**MEGQUIER & JONES INC.**  
 STRUCTURAL STEEL SINCE 1895  
 1156 BROADWAY  
 SOUTH PORTLAND, MAINE 04106

PAINT	HOLES U N	WELD U N	Q C REVIEW
PROJECT	TH NO.1 OVER THE GIBON RIVER PROJECT NO. BHO 1448 (29) BRIDGE NO. 5 TOWN OF JOHNSON, VERMONT		DATE 6-4-09
DESCRIPTION	CAMBER DIAGRAMS		DRAWN BY EJK 5-22-09
ARCH	N/A	ENGR VERMONT AGENCY OF TRANSPORTATION	CHK'D BY GDC
CUSTOMER	S.D. IRELAND CONCRETE CONSTRUCTION CORP.		JOB NO J-81
			SHT NO 3

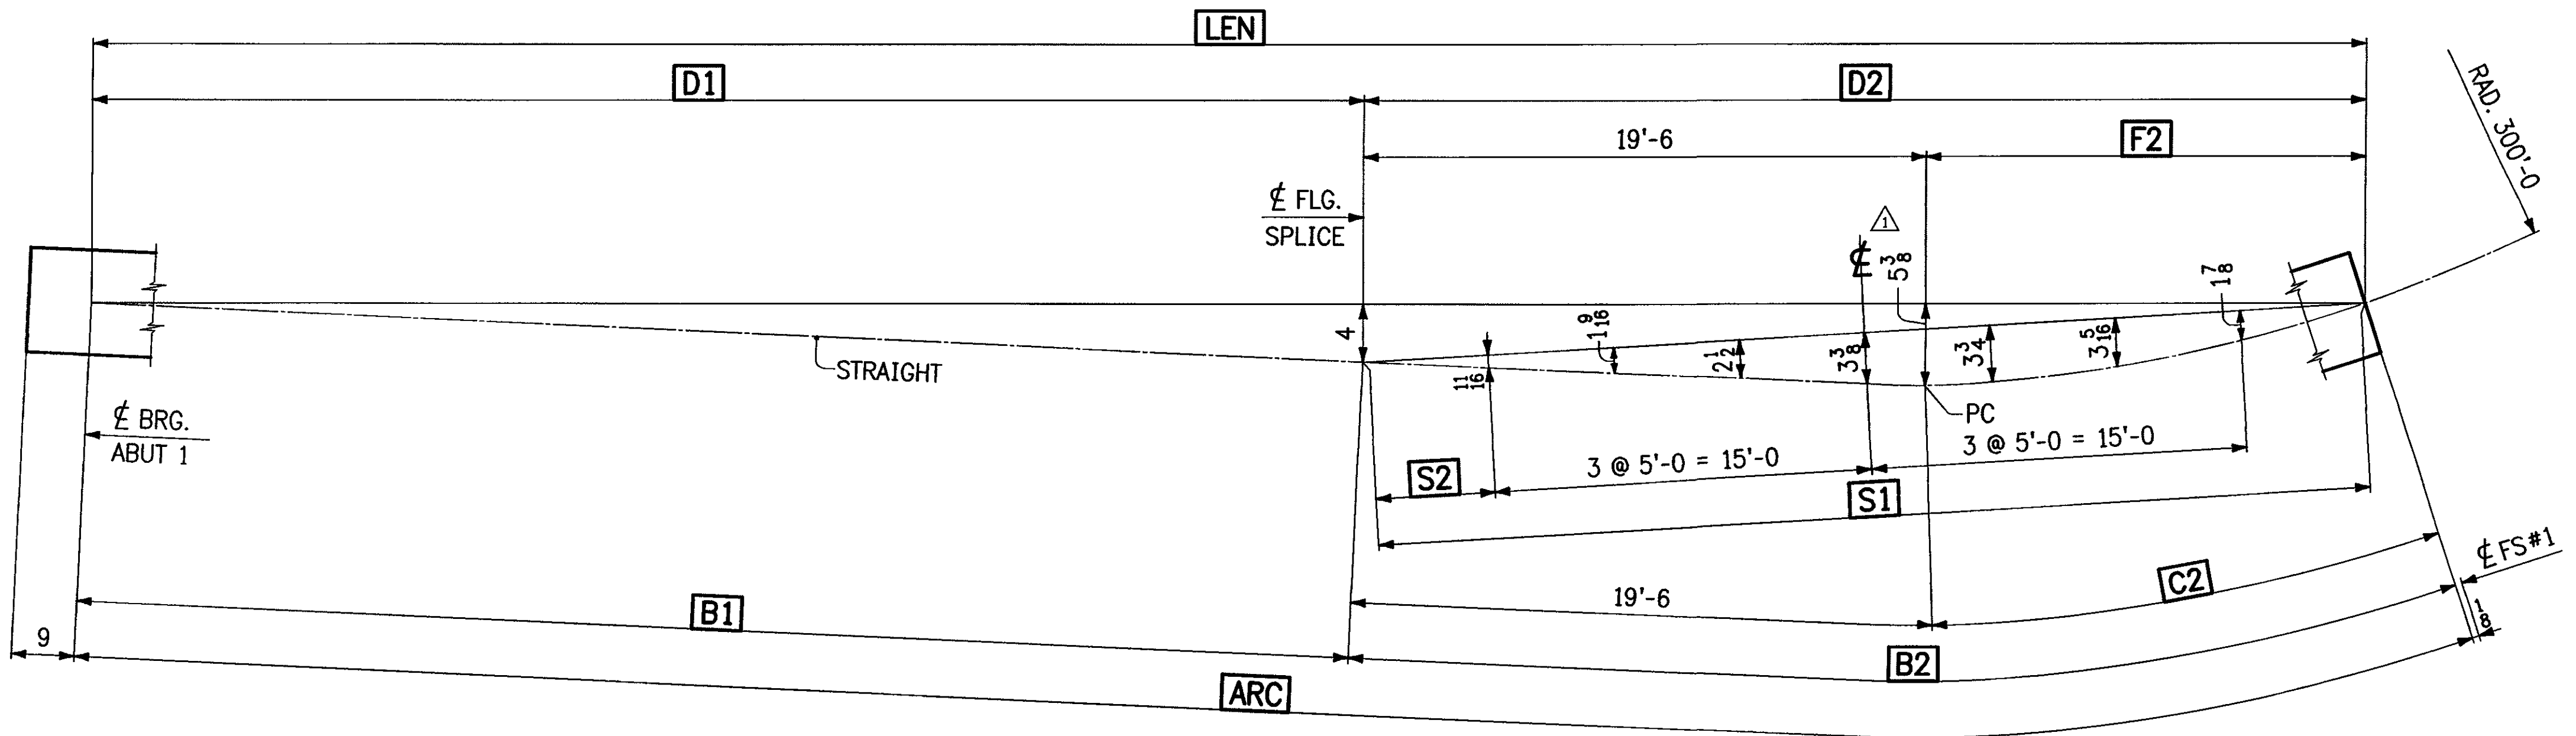
REVISIONS			PRINT RECORD		
NO	DATE	DESCRIPTION	DATE	QTY	ISSUED
7-14-09		REVISED HORIZONTAL CURVING DIAGRAM.	7-16	5p	Appr.

RECEIVED  
 OK'D BY JEL OK'D BY kmh  
 JUL 20 2009  
 APPROVED BY kmh DATE 7/21/09
